Project	<b>IEEE 802.16 Broadband Wireless Access Working Group</b> < <a href="http://ieee802.org/16">http://ieee802.org/16</a> >	
Title	<b>Radio Signature scheduling</b>	
Date Submitted	2007-07-10	
Source(s)	Mariana Goldhamer Alvarion Tel Aviv, 21 HaBarzel Street Israel	Voice: +972 3 6456241 Fax: +972 3 645 6204 <a href="mailto:mariana.goldhamer@alvarion.com">mailto:mariana.goldhamer@alvarion.com</a>
Re:	LE TG Call for Contributions	
Abstract		
Purpose	Approval	
Notice	<i>This document does not represent the agreed views of the IEEE 802.16 Working Group or any of its subgroups.</i> It represents only the views of the participants listed in the “Source(s)” field above. It is offered as a basis for discussion. It is not binding on the contributor(s), who reserve(s) the right to add, amend or withdraw material contained herein.	
Release	The contributor grants a free, irrevocable license to the IEEE to incorporate material contained in this contribution, and any modifications thereof, in the creation of an IEEE Standards publication; to copyright in the IEEE’s name any IEEE Standards publication even though it may include portions of this contribution; and at the IEEE’s sole discretion

Figure h51—Allocation of slots for BS and SS radio signature

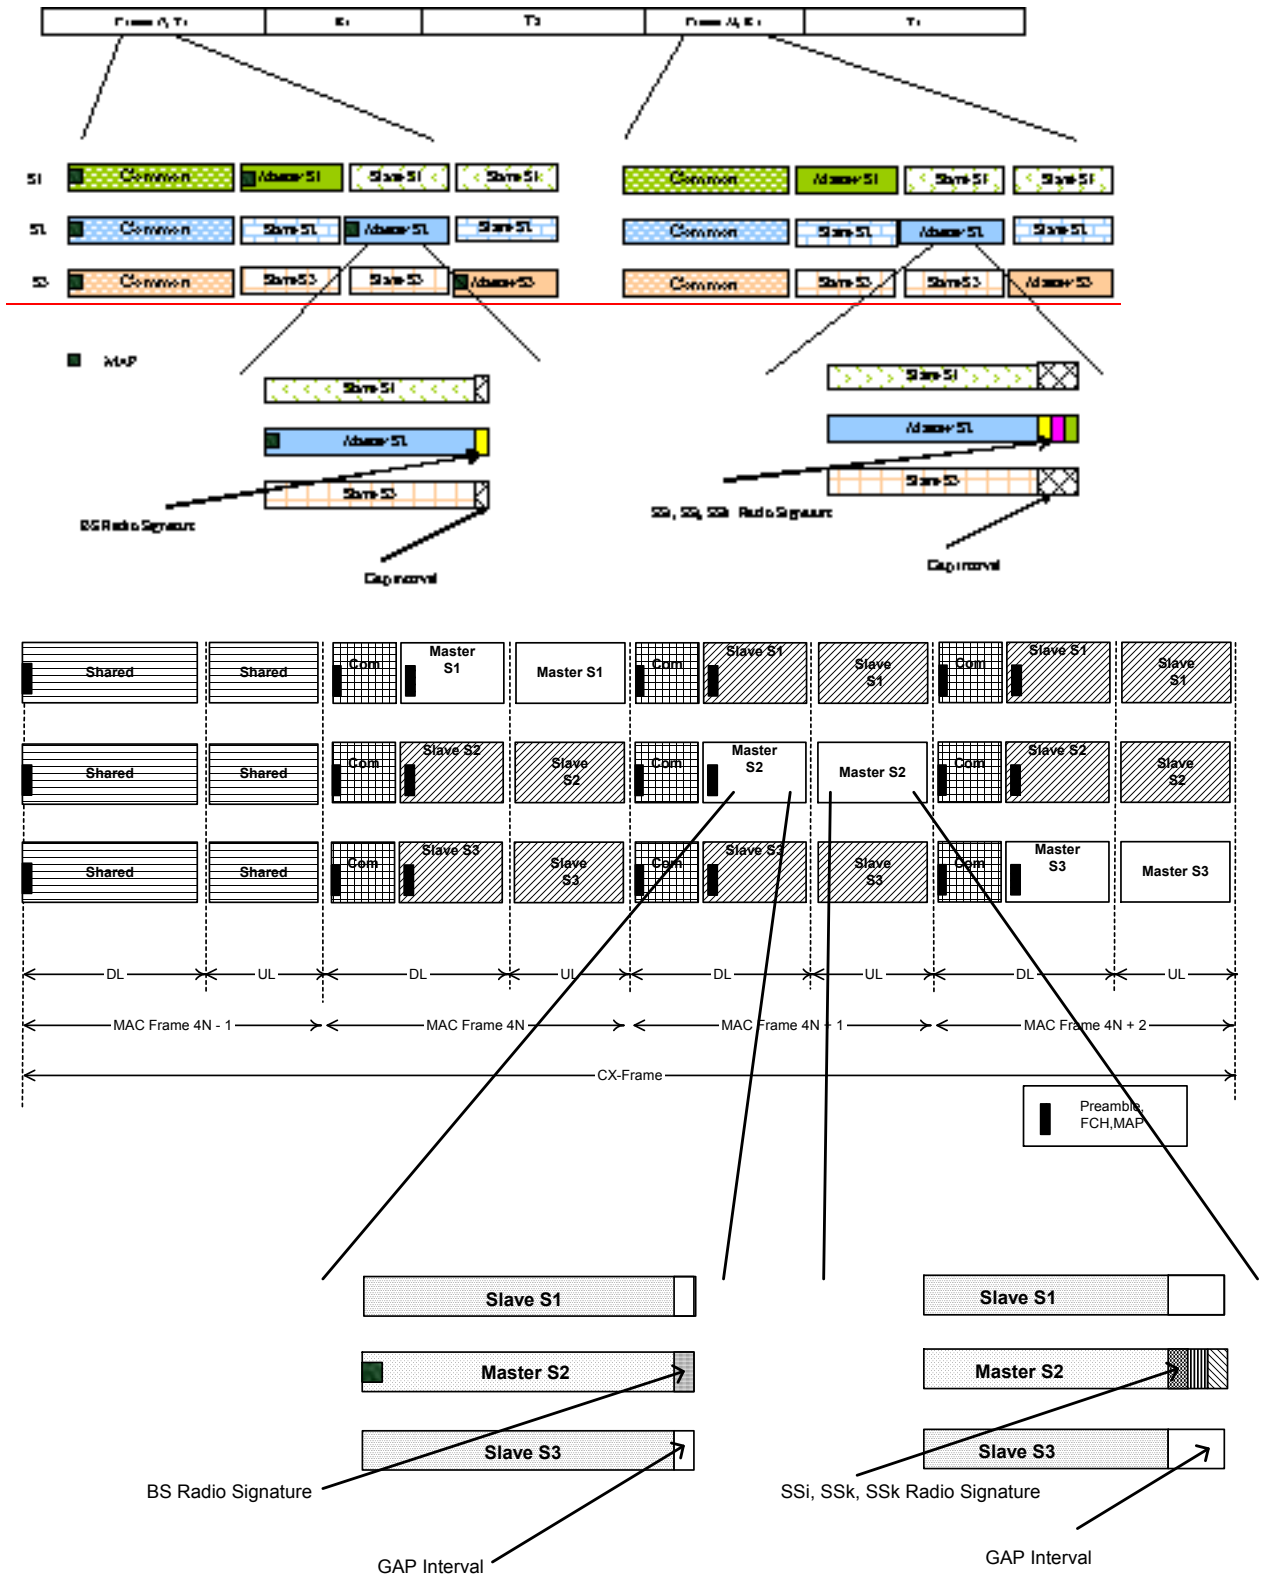
Alloca shows the possible allocation of the “radio signature” transmission opportunity for a given system, using for example the Type 1 repetitive pattern, with a focus on system 2.

The system 2 will transmit its Base Station radio signatures from time to time (every N MAC intervals); different radio signatures will be sent for every used power/sub-channelization/OFDMA sub-channel/ spatial direction combination. During these intervals the other Base Stations will schedule a Gap interval, in order to identify one Base Station solely. Base Stations using the same MAC sub-frame as the Master sub-frames shall schedule the transmission of their “radio-signatures” in such a way that they will not interfere with each other.

The transmission of “radio-signatures” used by the active SSs will take place during the Master sub-frame, from time to time (a timer shall be defined). The repetition period and the duration of the signature transmission shall be a parameter in the BS Database. The active SSs will provide a signature for every used power/OFDMA/sub-channelization/ direction setting.
